ADDENDUM NO. 2

March 28, 2022

WESTCHESTER INTERMEDIATE SCHOOL ADDITIONS AND RENOVATIONS Chesterton, IN 46304

MV108

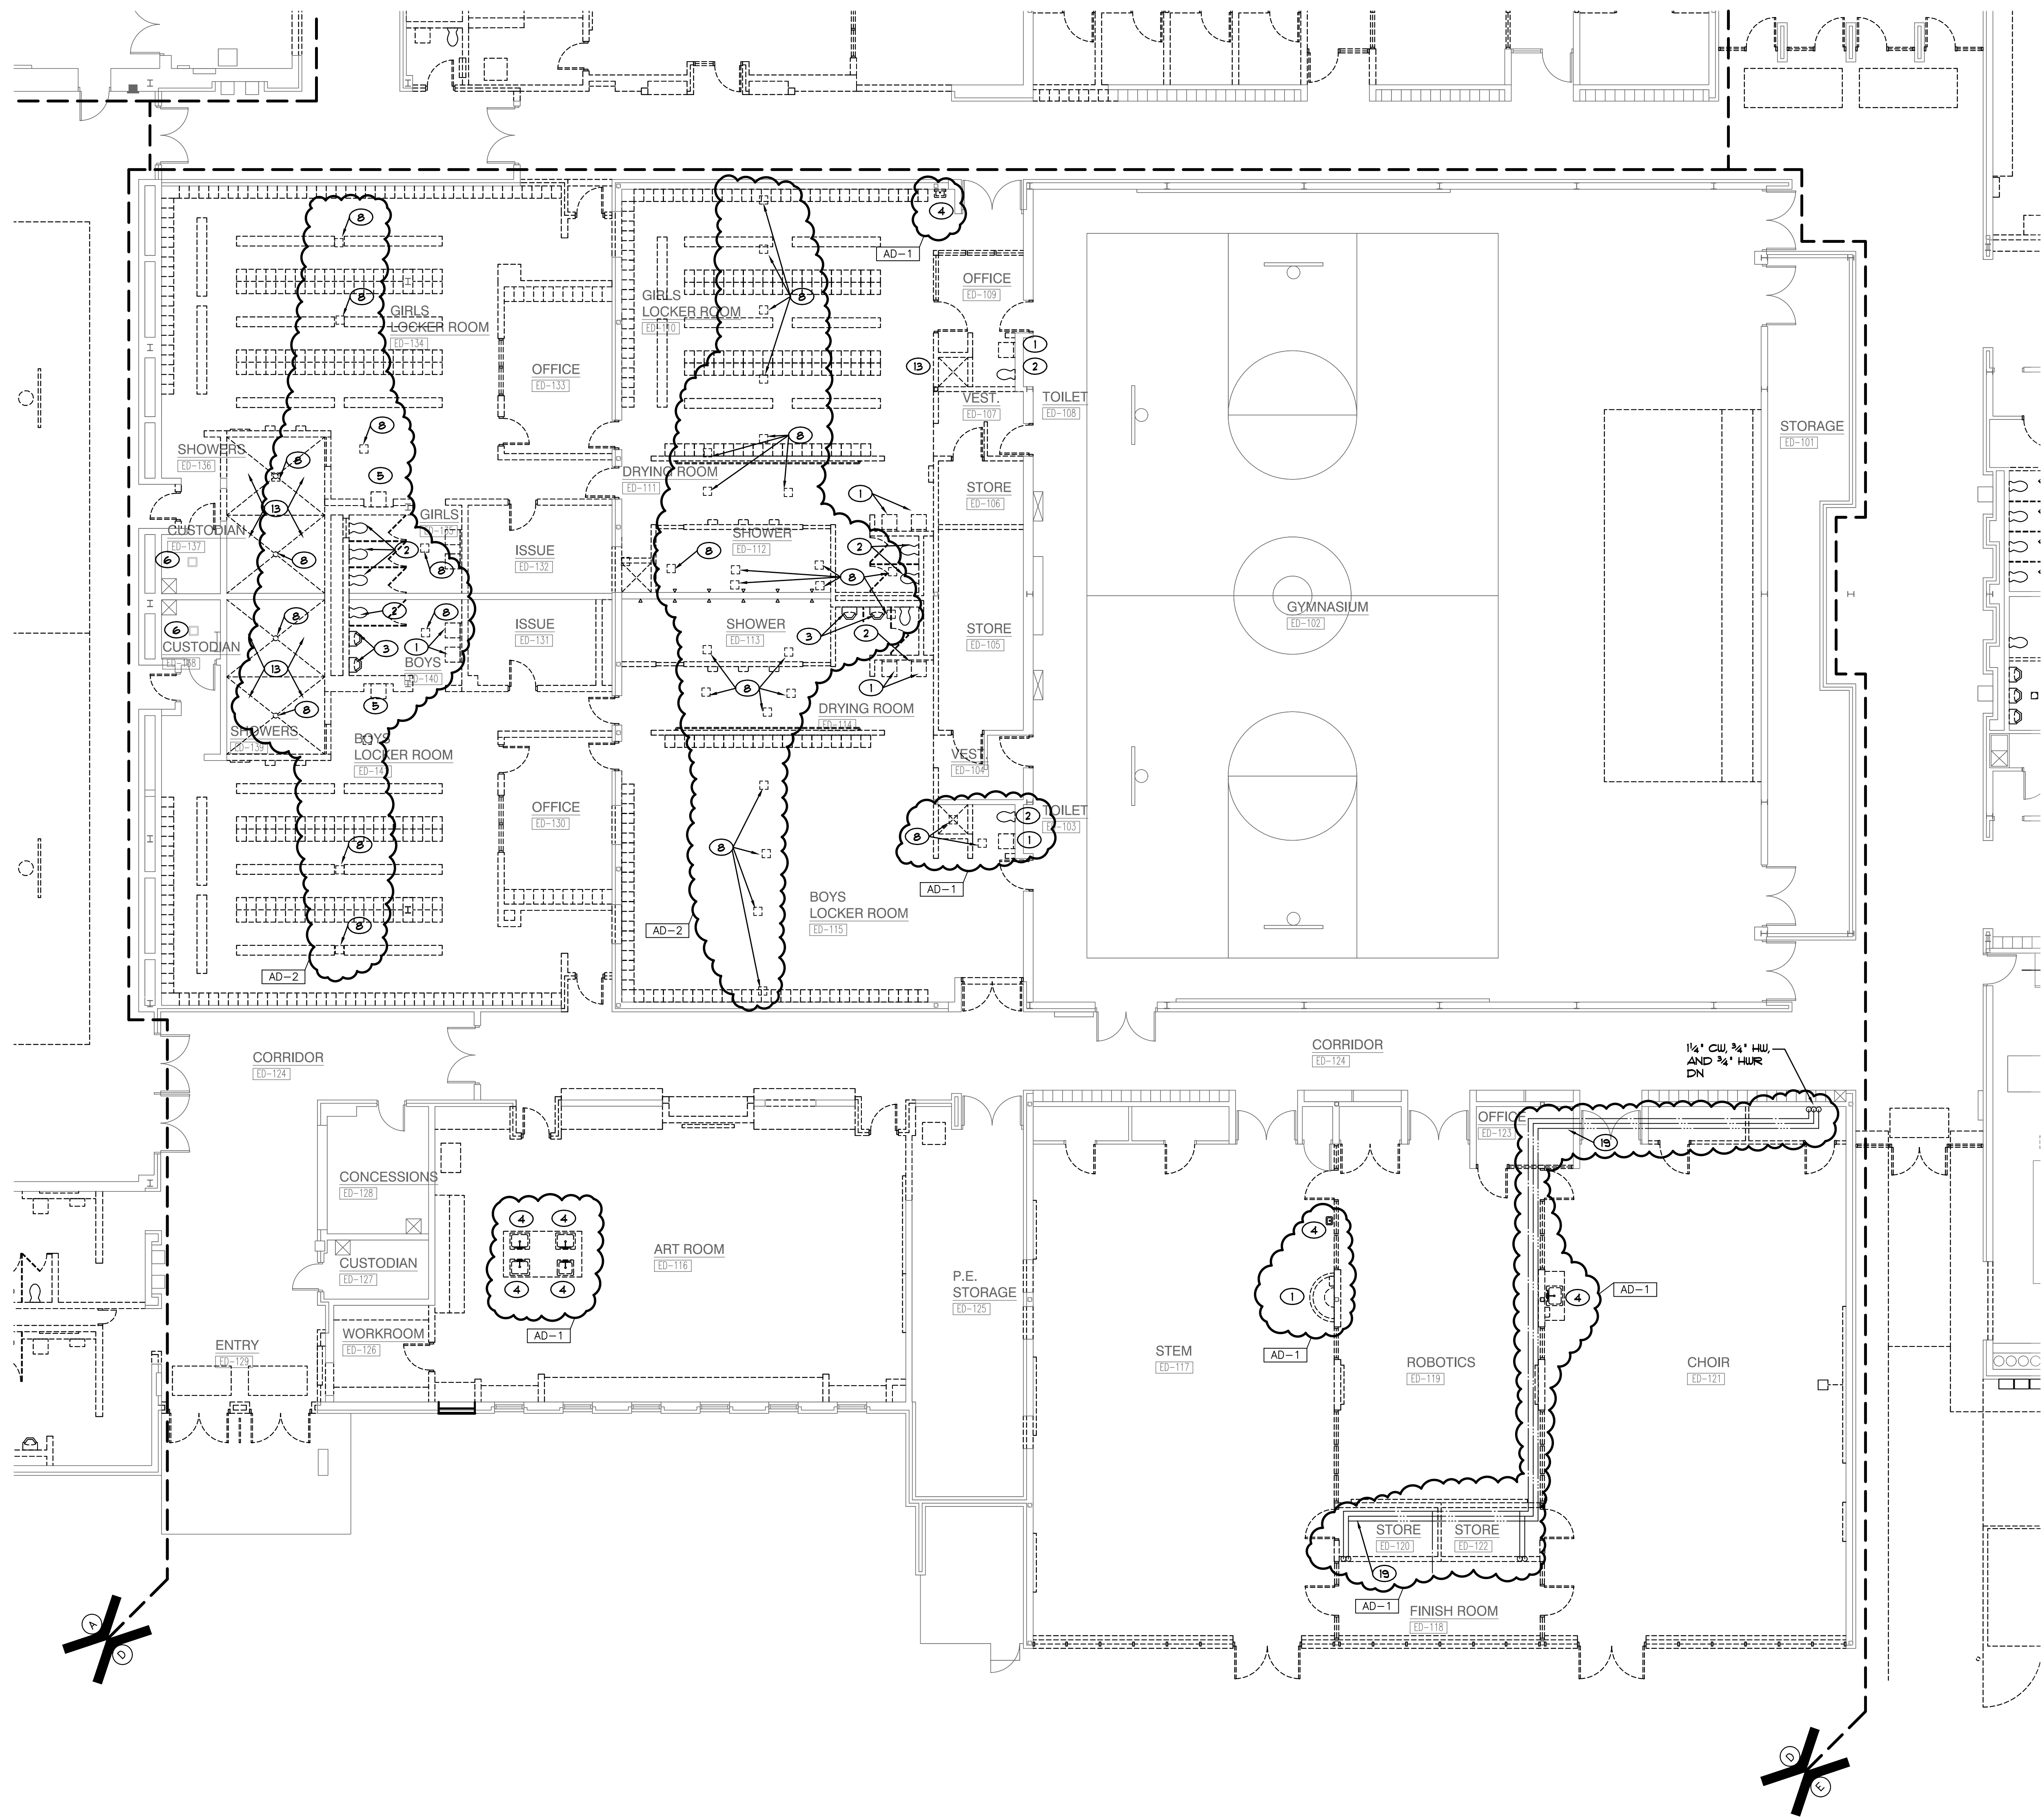
- A. Refer to revised, full-size drawing included in this Addendum, for the following revisions:
1. Revised location of relief duct.
 2. Added return to FC-2 and FC-3.
 3. Revised louver note.

© GIBRALTAR DESIGN SHEET
E EL104

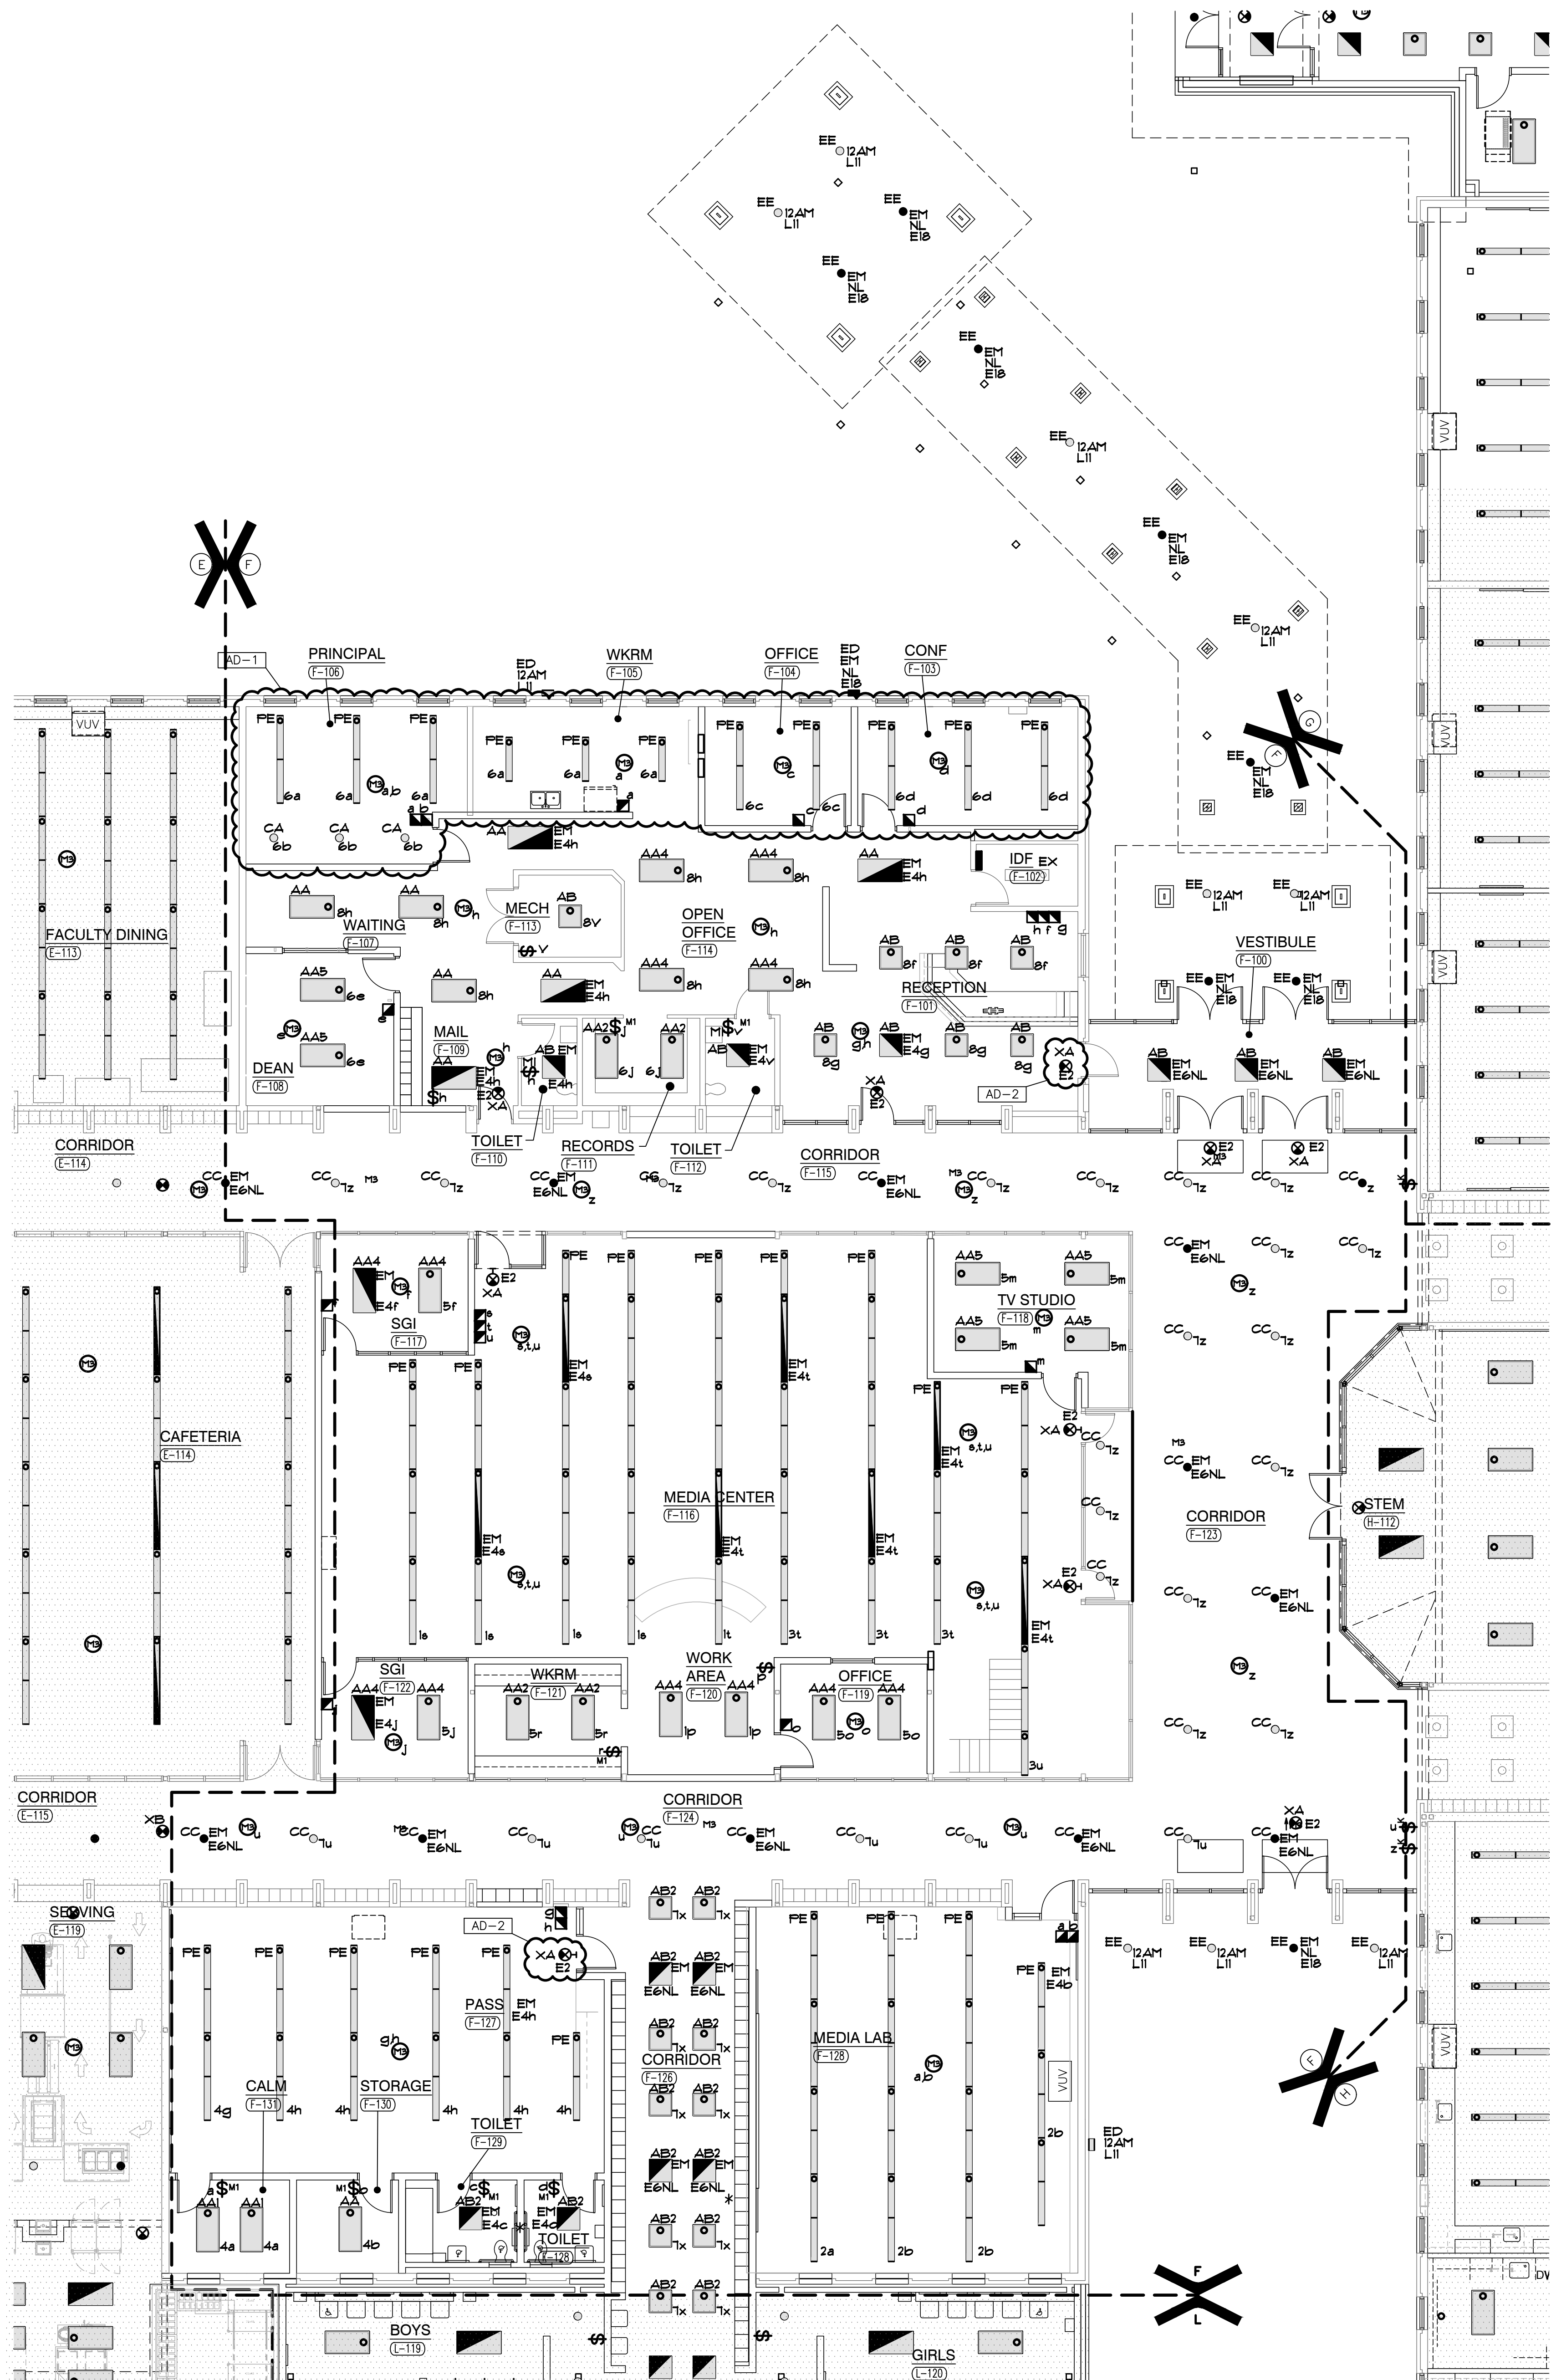
- A. Refer to revised, full-size drawing included in this Addendum, for the following revisions:
1. Revise lighting in Mechanical Room E-129.
 2. Delete (2) exit signs in Kitchen E-122.
 3. Add (1) exit sign in Kitchen E-122.
 4. Add (1) exit sign in Receiving E-131.
